Product Change Notice (PCN)

PCN Number: PCN-0454694R-01

Product(s) Affected: Part # UP2-AH-1-TH

Additional Information: See picture below for visual changes

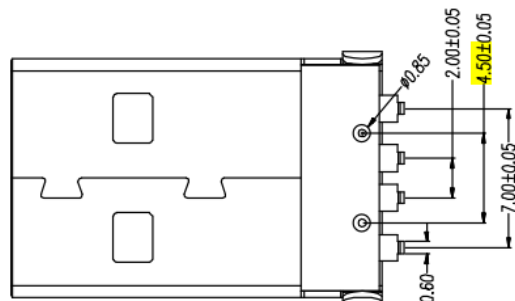
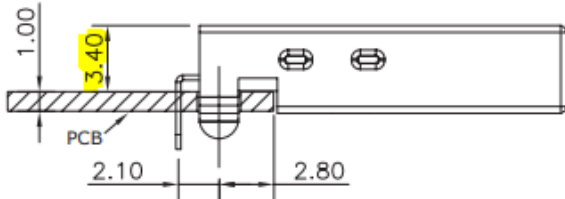
Description of Change: Pegs pitch now 4.5mm vs OLD 4.6mm & height now 3.2mm vs OLD 3.4mm. There are some small visual changes on the front, rear and side of the part. The part is still functionally the same.
